## Brisbane Central Business District Bicycle User Group

The CBD BUG was surprised and pleased at your announcement at the Brisbane Bicycle film festival that stage 4 of the North Brisbane Bikeway has now been opened to tenders.

Figure 1

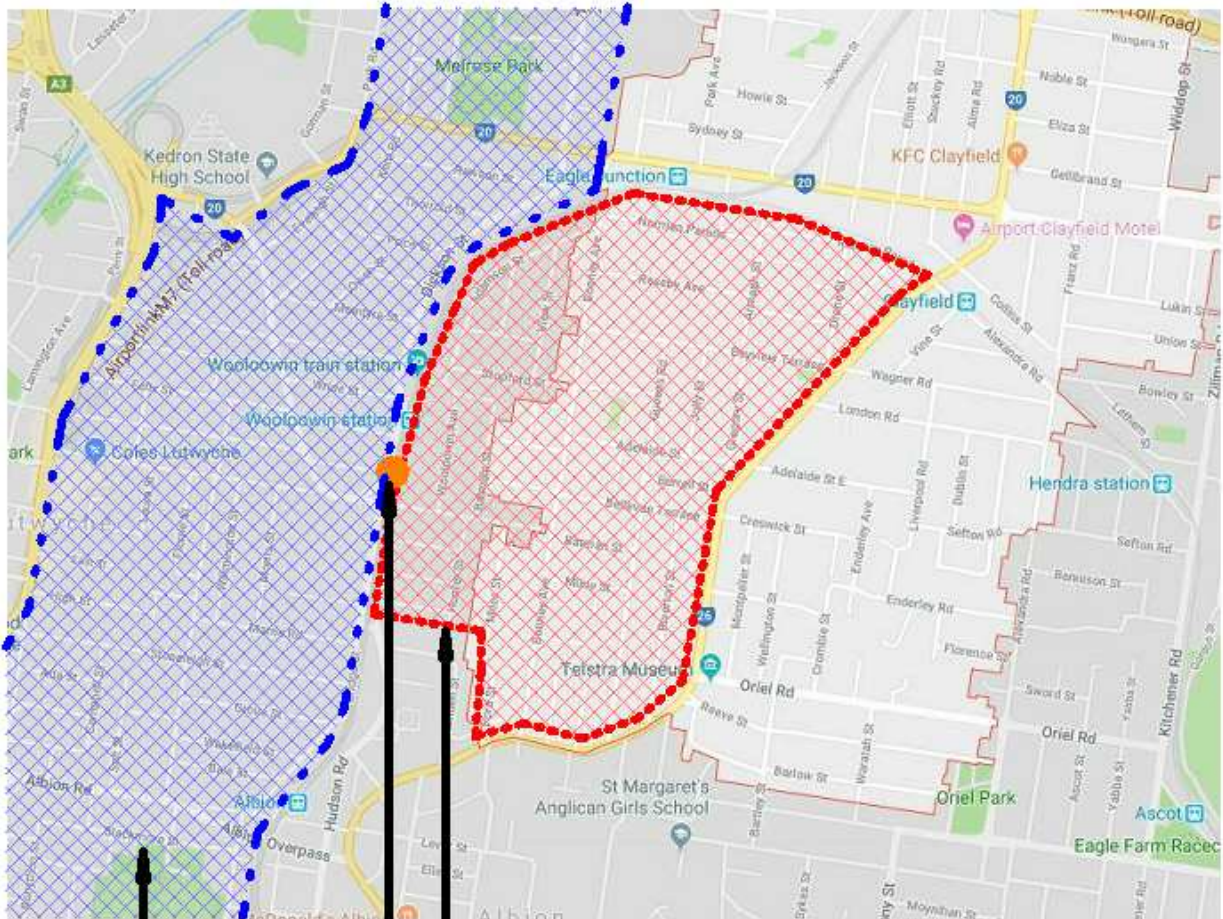
Due the protracted history of this project the CBD BUG does not want to delay the delivery, which the CBD BUG views as vital in the enabling of everyday practical cycling. That said, during the BCC consultation last year, a slight amendment to improve the catchment of the project was raised by the BUGs (Figure 1). While the project is highly regarded for its quality of design it is difficult for people on the east of the rail line to access it easily. To resolve this issue it was suggested traffic lights be installed at the Fraser St Bridge. The CBD BUG still strongly supports through traffic being prevented from using Fraser St via its reconfiguration as a cul-de-sac. The installation of the lights is to simply allow improved access and safety for people coming from the east side of the railway tracks.
